Ref: SSD-79276958

RE: SUBMISSION TO SSD-79276958 FOR RESIDENTIAL FLAT BUILDING WITH INFILL AFFORDABLE HOUSING

ATTACHMENT 1

Figure 3 – Height Plane Drawing

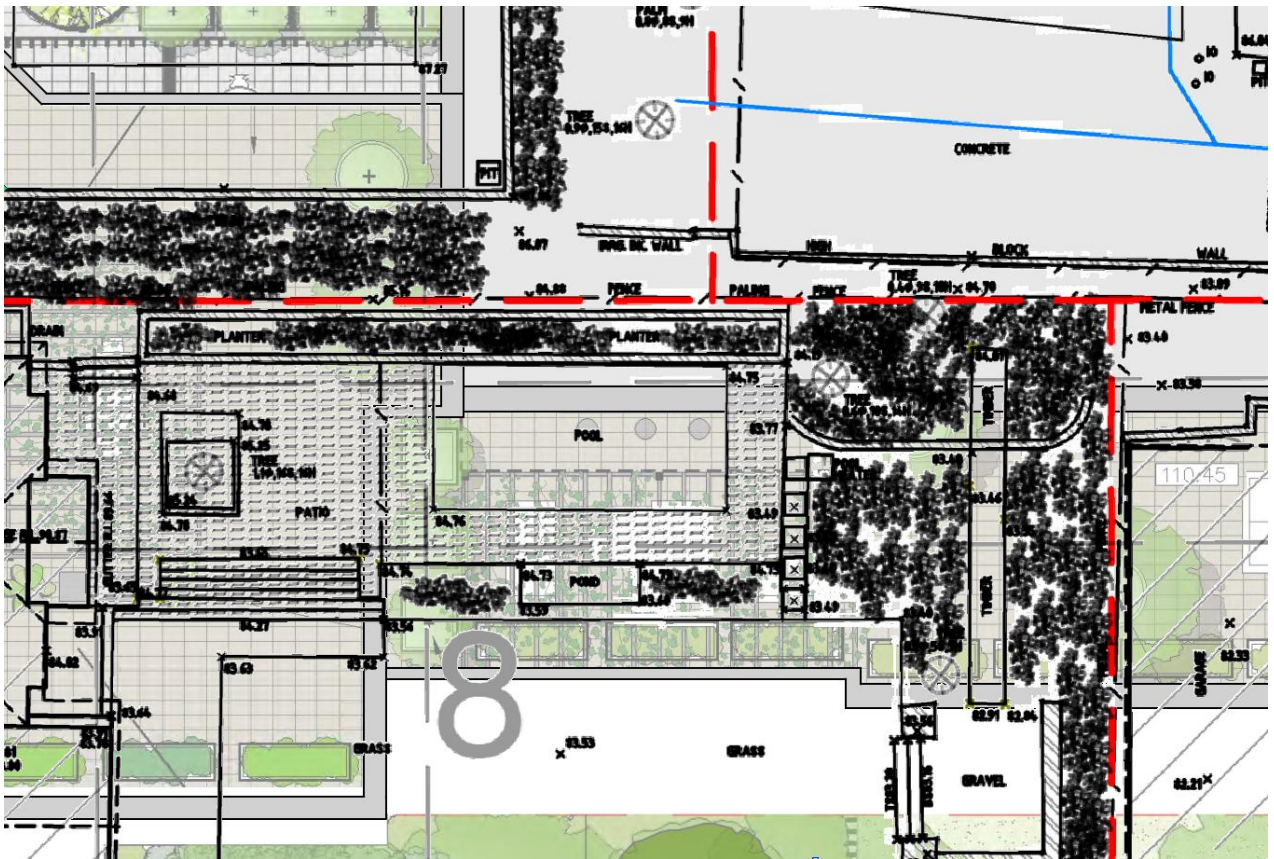
A Clause 4.6 written request forms part of the application, indicating a maximum building height of 33.07m which exceeds the maximum building height by 4.47m (15.60%). The subject application's 'Height Plane' (drawing no. DA500) drawing is provided in **Figure 3** below:

Based on **Figure 2**, it is observed that the largest non-compliance in building height occurs at the roof parapet of the proposal (+4470). However, the maximum building height of the proposal cannot be correctly calculated due to insufficient detail on the architectural plans provided. It is acknowledged that the 'SITE PLAN' (drawing no. DA102) contains proposed roof level RLs. However, when attempting to assess the maximum building height contravention (+4470) by overlaying the 'SITE PLAN' with the exhibited Survey Plan, EGLs directly below this point are not annotated. This can be observed in **Figure 4** below:

The extent of variation is not considered to be “...*limited to a part of the uppermost levels*”. Rather, it is considered that significant portions of the roof exceed the maximum building height. This is particularly evident on the proposal’s north-western roof, as depicted in **Figure 2** above, where only a minor portion of the roof complies with the maximum building height. The Clause 4.6 also states:

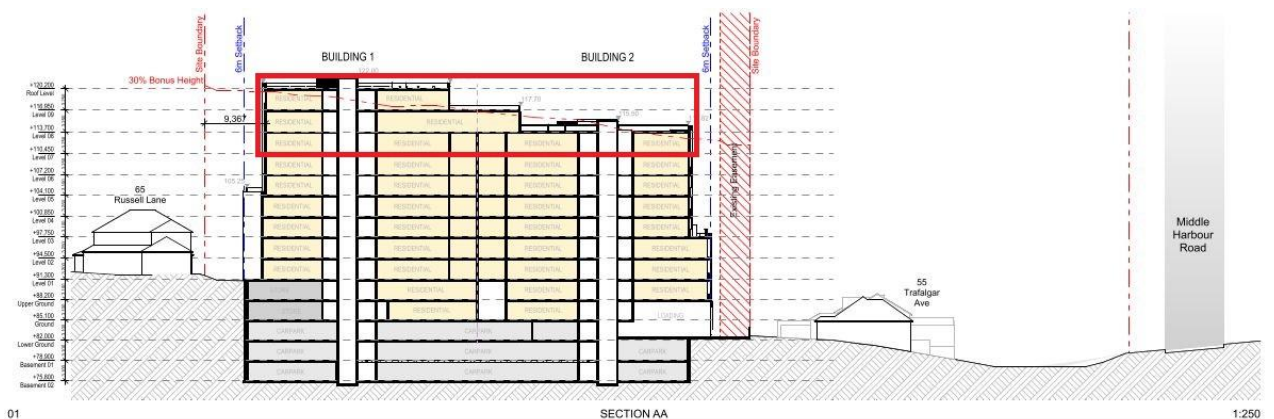
However, 'SECTION AA' (drawing no. D310) otherwise confirms the inconsistency with this statement as provided in **Figure 6** below:

The breach in the maximum building height, as indicated on the architectural plans, is significant and amounts to large portions of the roof and the top floor of the development. For the Clause 4.6 variation request to be well founded, the variation from the development standard must be clearly articulated and justified. The consent authority must be satisfied that the Clause 4.6 variation is well founded before the granting of any development consent. With respect to Clause 4.6(3)(a) and (b) of the KLEP, it is Council's opinion that the variation request has not demonstrated that:

Figure 7 – 'WASTE STORAGE ROOM' Spot Level at RL83.63

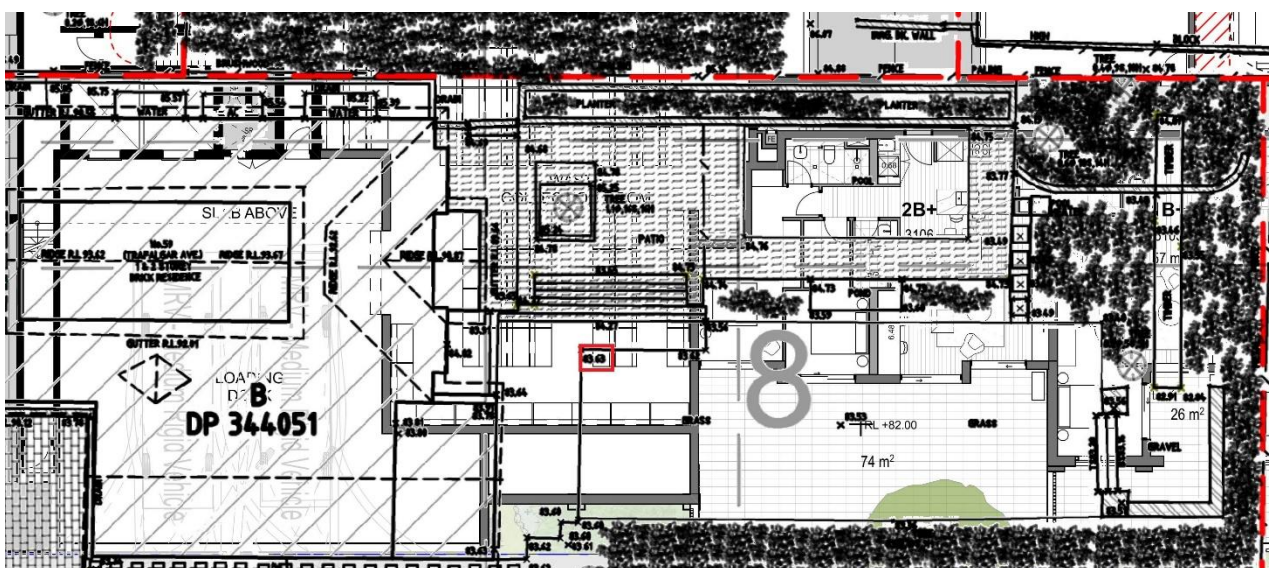
- the 'LOWER GROUND FLOOR' has excluded the denoted 'WASTE COLLECTION ROOM' and the 'WASTE ROOM' directly adjacent to a 1-bedroom and 3-bedroom apartment. EGL RLs of both rooms were identified by overlaying the 'Lower Ground Floor' plan (drawing no. DA202) with the exhibited Survey Plan. For the 'WASTE COLLECTION ROOM', there are several instances where the RL is less than RL84.10. For example, a spot level at RL83.63 within the 'WASTE COLLECTION ROOM' is provided in **Figure 7** below:

- Similarly, this applies to the 'Lower Ground Floor' 'WASTE ROOM' where a spot level at RL83.89
